PROJECT
The Hoo: Scheme 3
17 Lyndhurst Gardens,
Hampstead, London
 Returning A Grand Victorian House To Private Domestic Accommodation
 NW3 5NU

DRAWING
Lower Ground Floor Layout
as Proposed

JOB No. 19013 **DRAWING No.** 1120 **REVISION** M
STATUS PLANNING

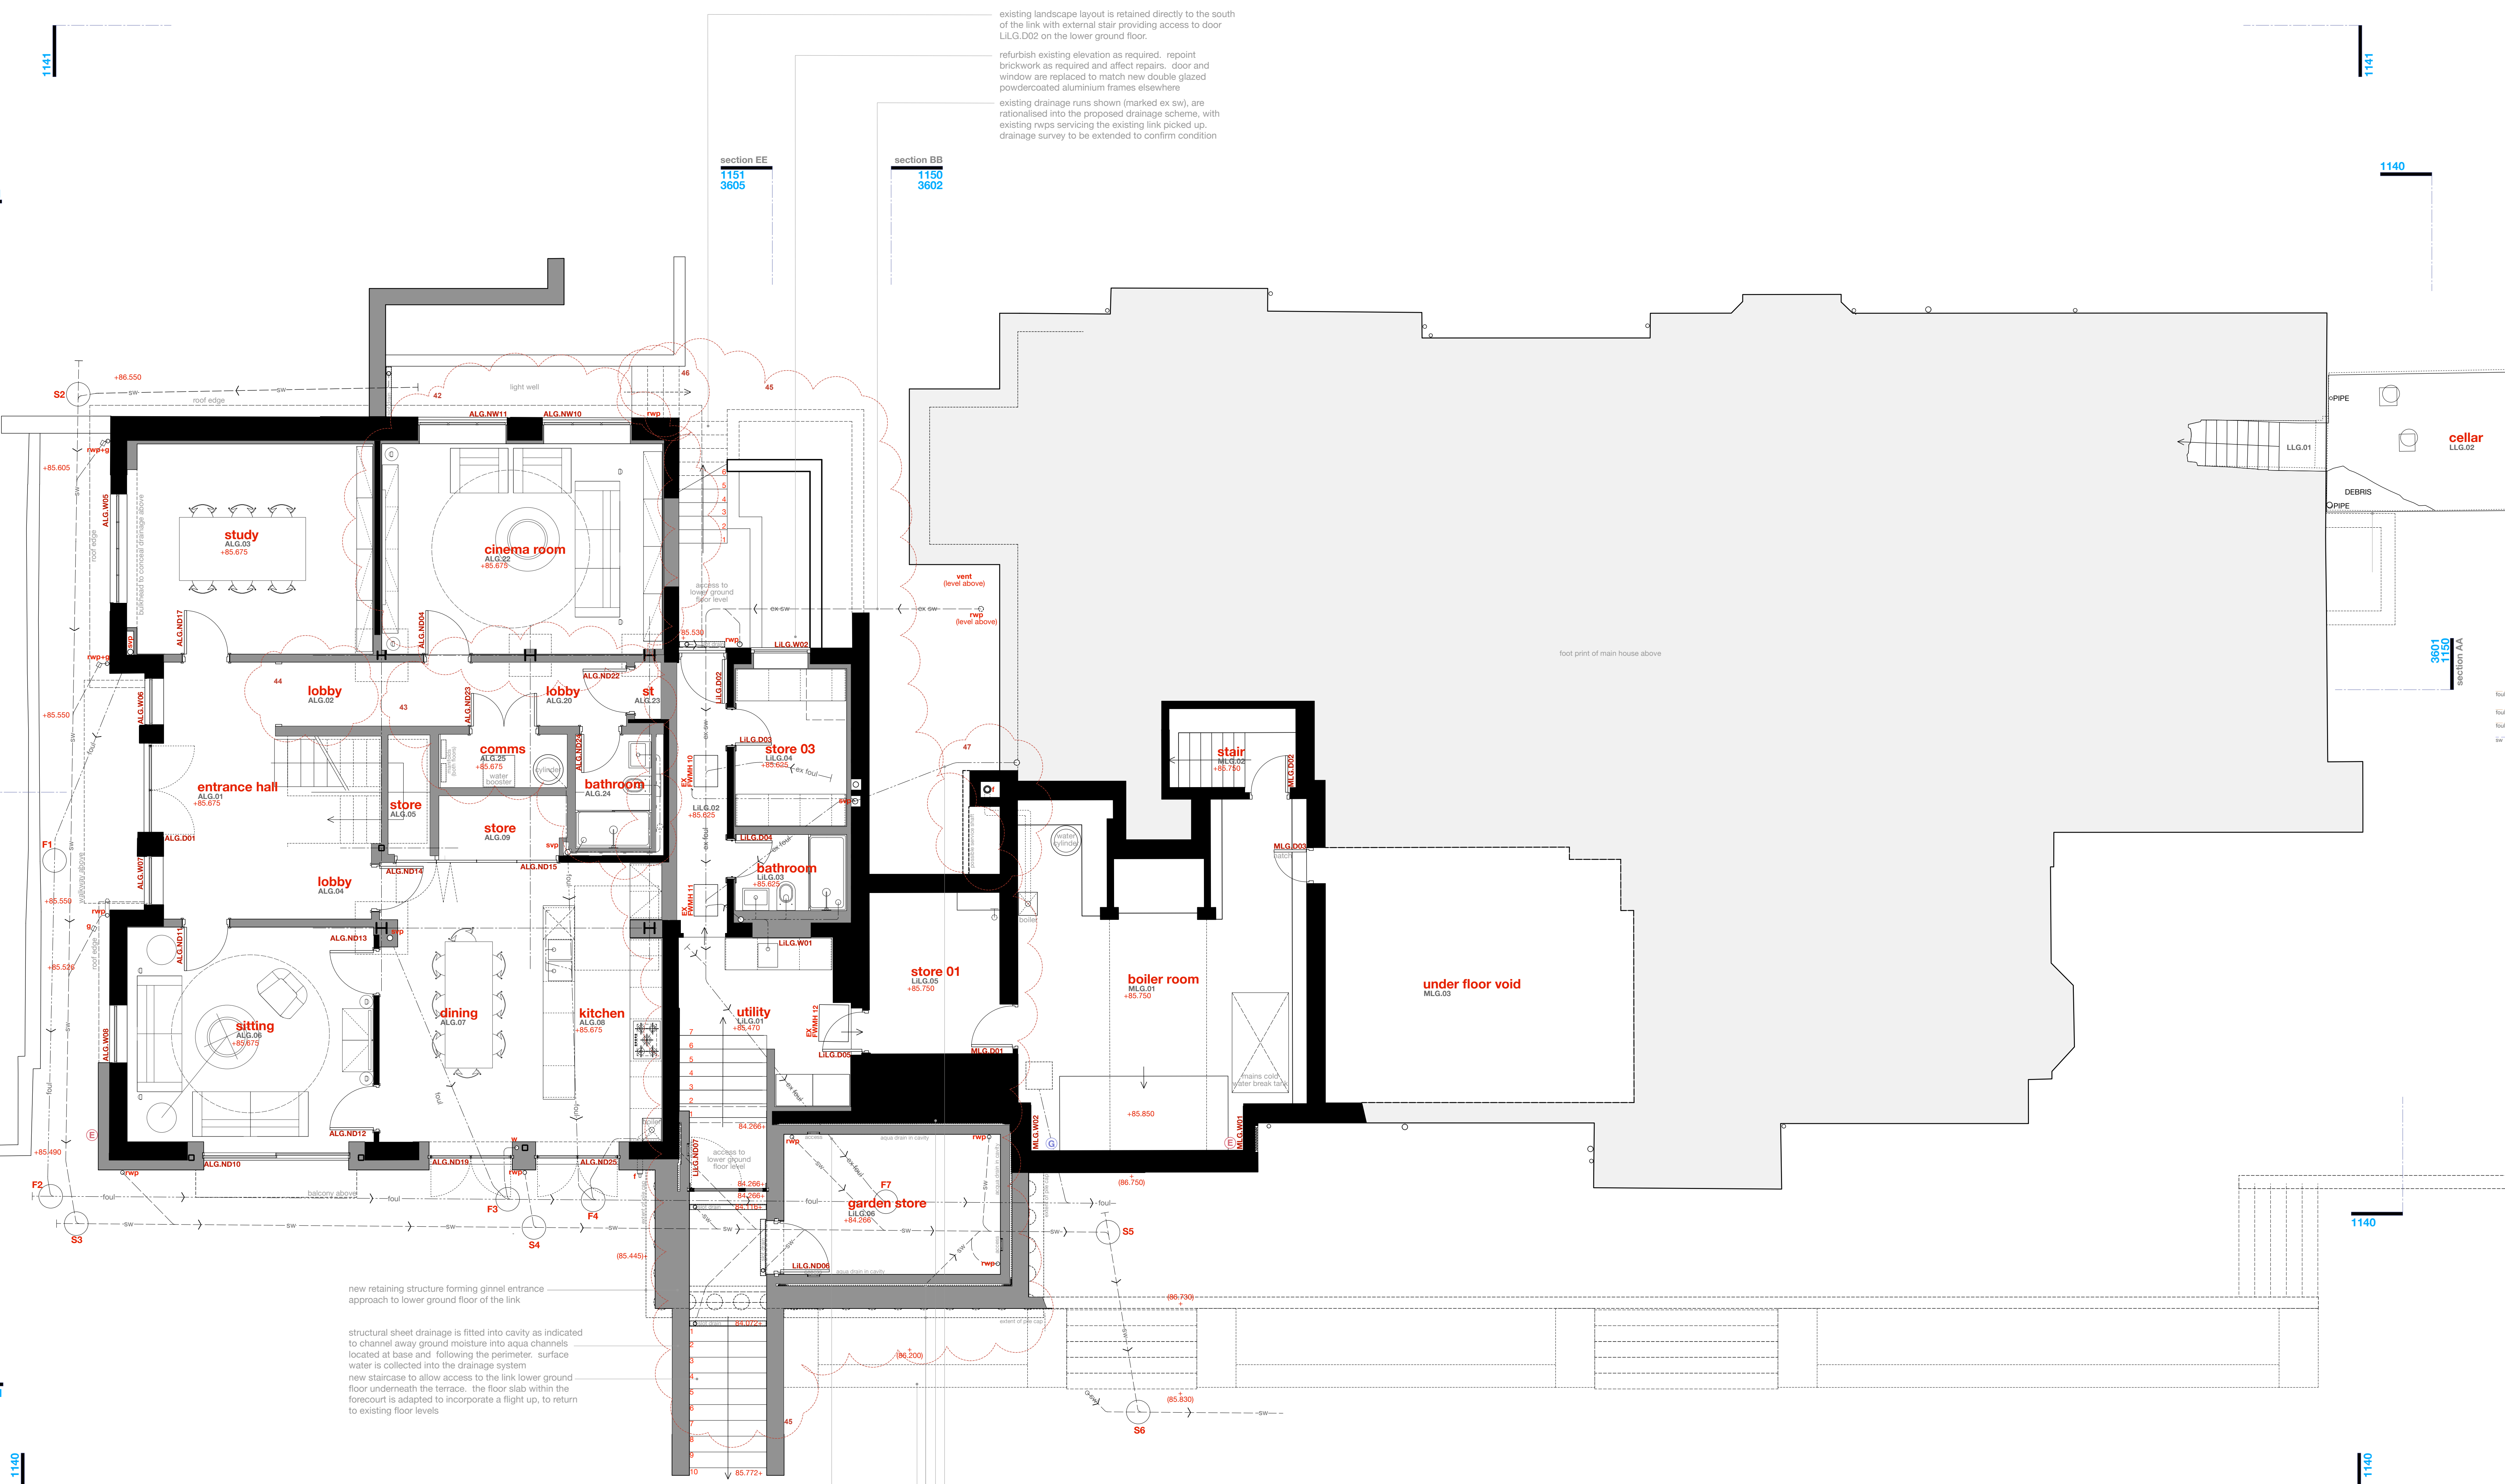
- 42** annexe: former rainy and staff room, which were within the main house dormer. becomes a small cinema room and repatriated into the annexe dormer

- 43** annexe: cinema room, bathroom and circulation formerly associated with the rainy and staff rooms are repatriated into the annexe dormer
- 44** annexe: former wc is omitted

- 45** link: proposals for contemporary new built link and associated landscape to front and rear are omitted. revised scheme is simplified and reduced. amended design follows the volume and structure of the existing building and retains existing masonry facade to the north and south. flat roof and structure are removed and replaced with new incorporating improved thermal performance. single glazed glass roof and south elevation are removed and replaced with new double glazing filled to powder coated aluminium frames. new glazing in wide pane formats allows an improved view of the garden from inside the office. revised proposals are naturally ventilated and more simply heated.

- 46** external staircase leading to lightwell at rear of annexe simplified and returned through 50 degrees
- 47** possible existing service shaft uncovered during additional investigations included on drawing

- REV M** 02 Oct 2024 GM/G
 Adjustments made to ginnel and garden store and staircase leading to lower ground floor to incorporate most up to date structural information. notes pertaining to earlier and approved applications are removed to improve clarity of the adjusted proposals

- REV L** 10 Jul 2024 GM/G
 Proposed link is revised again. South terrace dock is extended across the entire width of the link on GF and entrance at LGF level is revised to accommodate head height. Garden store is provided underneath terrace. Existing glazed roof and flat roof are removed and upgraded to include additional insulation and double glazing to improve thermal performance. Brickwork on south elevation is reduced to allow taller windows. Existing timber frames are removed in preference for powder coated aluminium with wider panes of glass

- REV K** 21 Dec 2023 GM/G
 Proposed scheme is simplified. Contemporary link is omitted and existing link structure is returned into the proposals. Dormers are simplified; former rainy and staff room become a small cinema room and repatriated back into the annexe

existing landscape layout is retained directly to the south of the link with external stair providing access to door LLG.D02 on the lower ground floor.

refurbish existing elevation as required. repoint brickwork as required and affect repairs. door and window are replaced to match new double glazed powdercoated aluminium frames elsewhere

existing drainage runs shown (marked ex sw), are rationalised into the proposed drainage scheme, with existing rwp's servicing the existing link picked up. drainage survey to be extended to confirm condition

new retaining structure forming ginnel entrance approach to lower ground floor of the link

structural sheet drainage is fitted into cavity as indicated to channel away ground moisture into aqua channels located at base and following the perimeter. surface water is collected into the drainage system

new staircase to allow access to the link lower ground floor underneath the terrace. the floor slab within the forecourt is adapted to incorporate a flight up, to return to existing floor levels

new section of internal drainage carrying foul waste from new wc MD.07 to existing drainage system in void below floor above. take up section of existing concrete / beam and block floor to install

limited underpinning required across width of the south elevation of the existing link

new retaining structure creating dry unheated storage space below the terrace

soft landscaping extended in front of terrace structure

existing drainage from the link is to be rationalised into the proposed drainage scheme. cctv survey is to be extended to confirm condition of re-utilised sections of existing drainage (marked ex sw/ex tou)
